RE: Juneau Hydropower Inc. Submission of Response Comments from Notice of Intent to Prepare Environmental Impact Statement and Soliciting Comments, and Final Recommendations, Terms and Conditions, and Prescriptions dated November 17, 2014 for Project FERC P-13563-003 Sweetheart Lake Hydroelectric Project

Comments on Volume 2 PDEA and Appendices of the Final License Application for Sweetheart Lake FERC Project P-13563

USDA Forest Service, Alaska Region, Tongass National Forest

**FIGURE 1 - SWEETHEART CREEK
SPAWNING HABITAT ASSESSMENT AREAS**

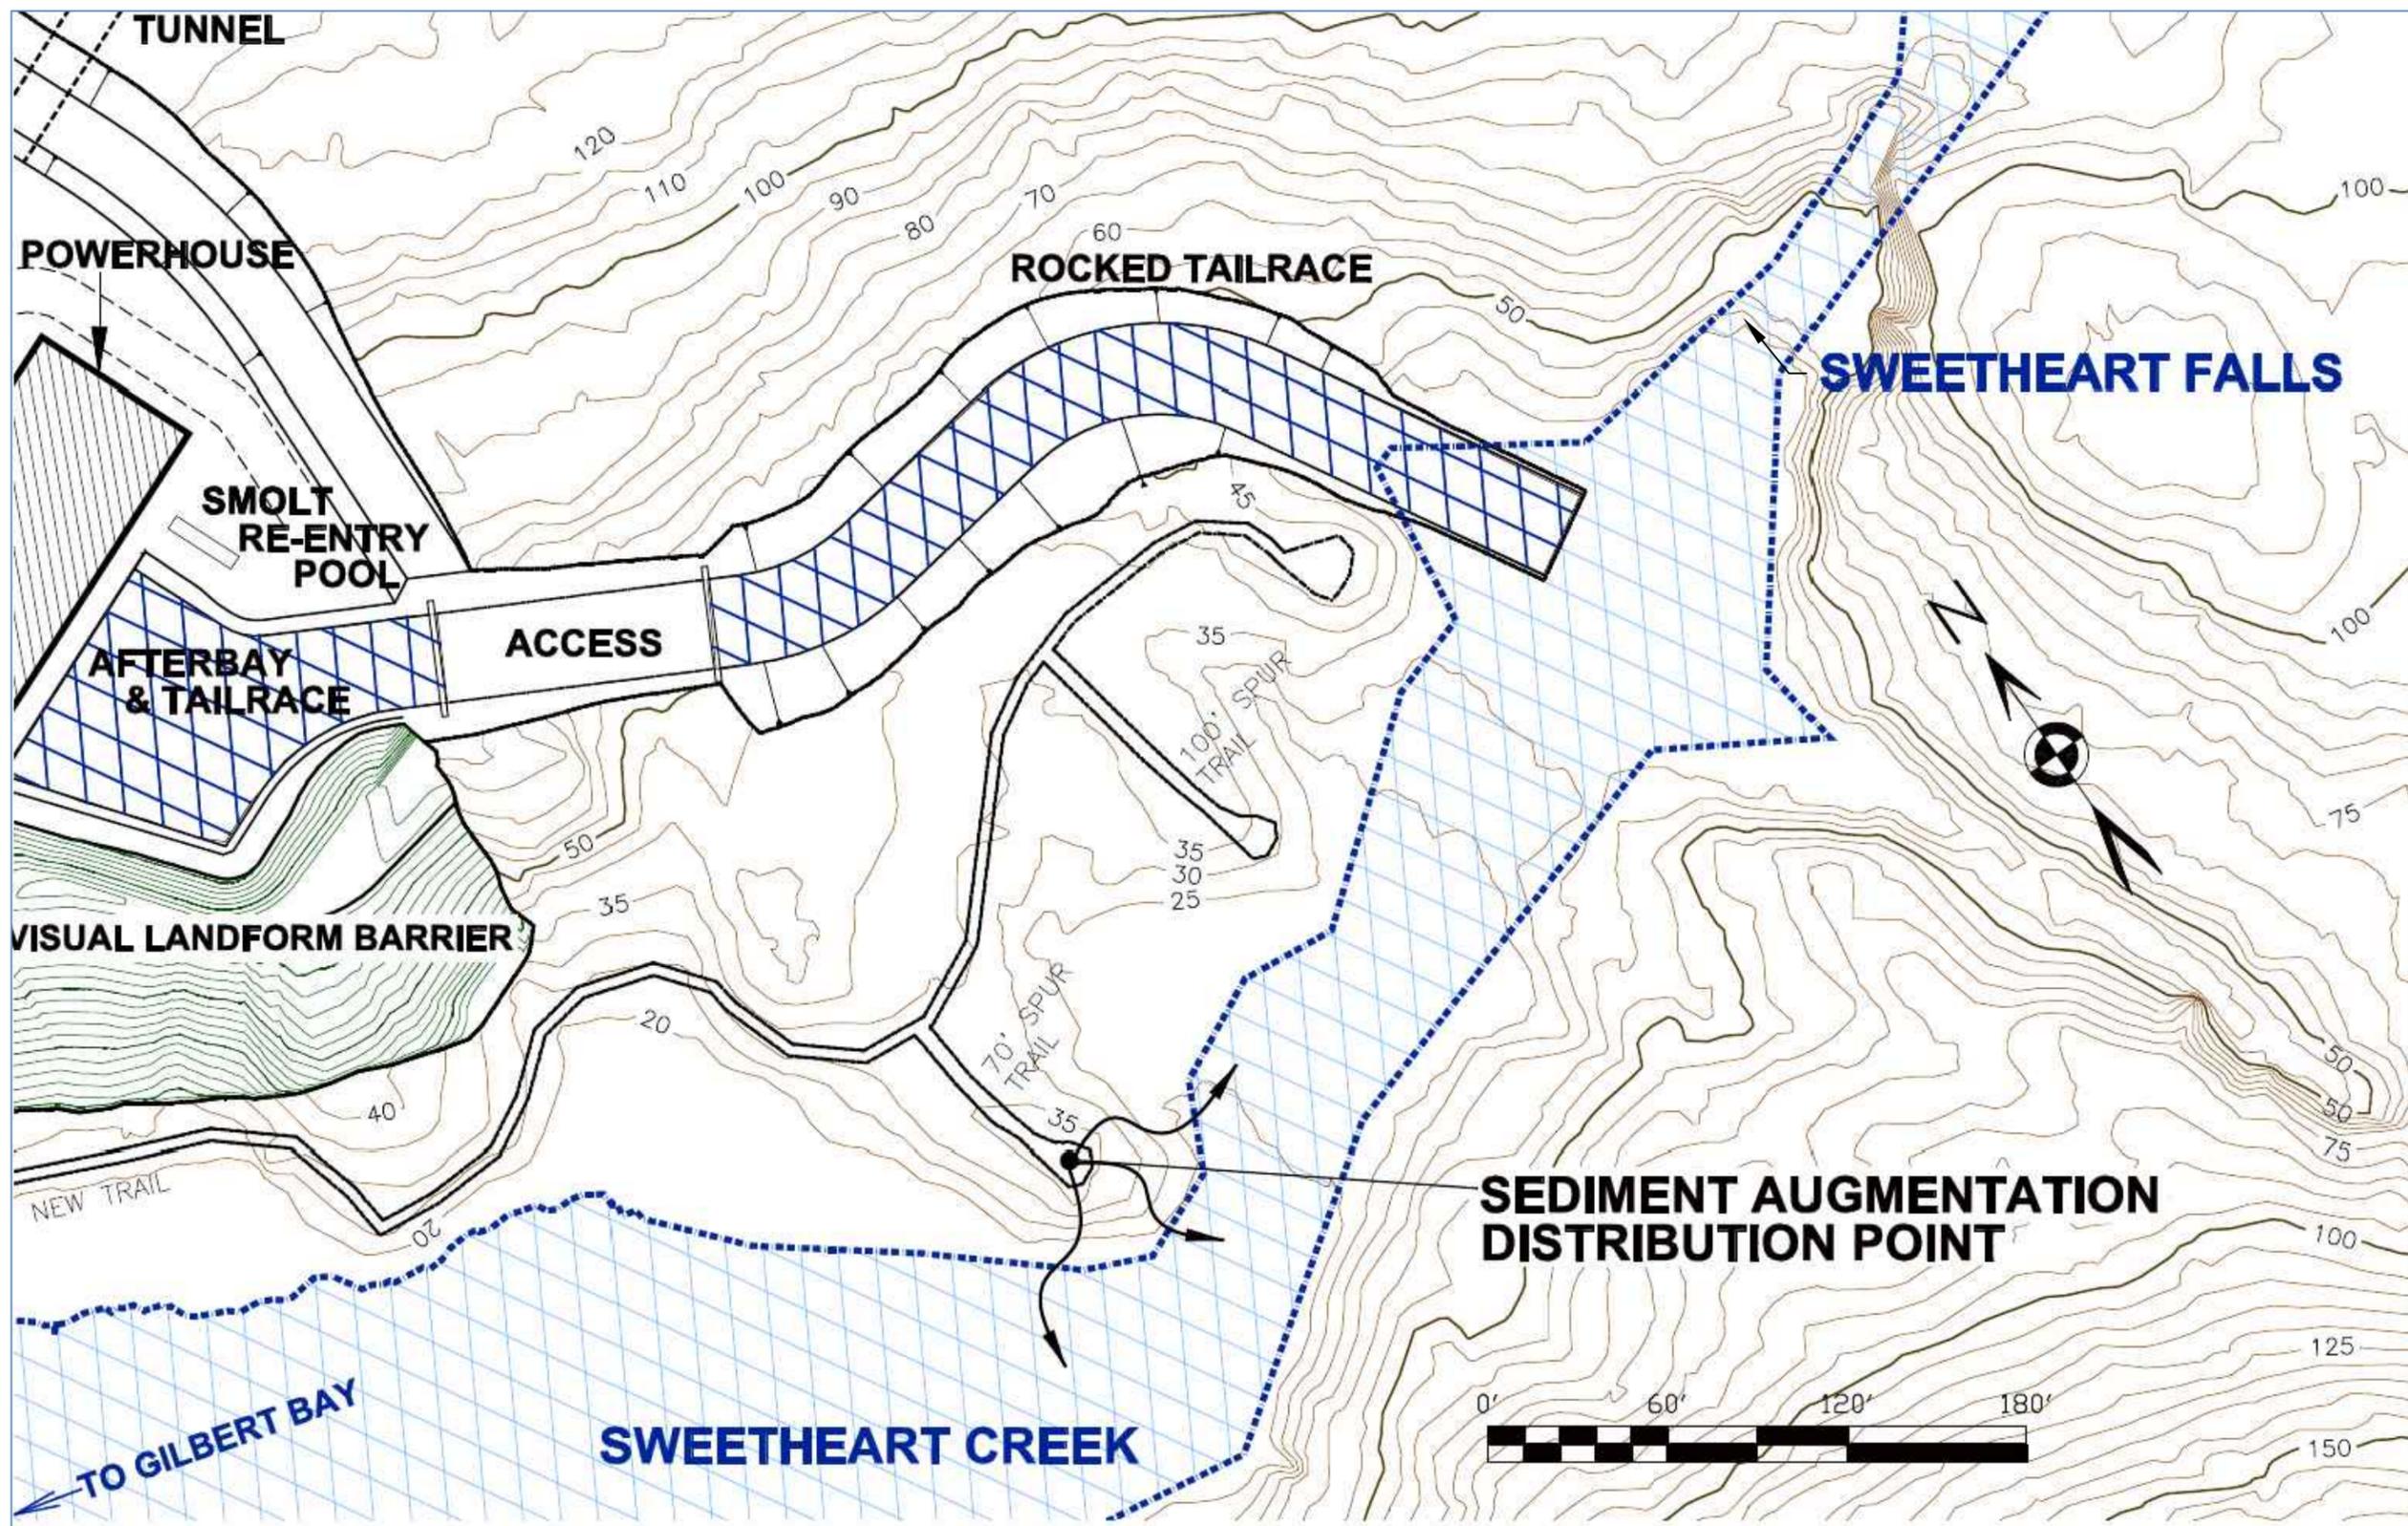
135	643	PDEA 5.5.11: Alaska DFG 11. Stream Buffers and Location of Facilities	2. As part of AHRMP, gravel augmentation may eventually be required. As such, JHI would require an exemption from this proposed rule to perform this activity.	Need more details on gravel augmentation project and the work proposed within the 100-foot buffer.		This is an Alaska DFG requirement for work in the 100 foot buffer and as such a Habitat Permit will be resolved with Alaska DFG. See also response to comment 130
136	?	Missing from PDEA		I would like to see a schematic of the tailrace. How will a 30ft deep tailrace join into the main channel of Sweetheart Creek? If the flow of the tailrace is perpendicular to Sweetheart Creek, how will that affect the bank across from the tailrace? It’s hard to picture.		Tailrace details are shown on Exhibit F, Figure F-9 and Figure F-12. See response to comment 119
137	5	Appendix W:Attachments : Figure 1 Spawning		This map needs to be more detailed and clarified. It shows Sweetheart Creek of to the West of the tailrace? Shouldn’t Gilbert Bay be off to the West? And Sweetheart Creek should come in from the North East? The figure should		Comment noted, Figures 1 & 2 are clarified and submitted with comment responses.

SWEETHEART CREEK - ANADROMOUS REACH SPAWNING HABITAT ASSESSMENT AREAS
(REVISED 2/17/2015)
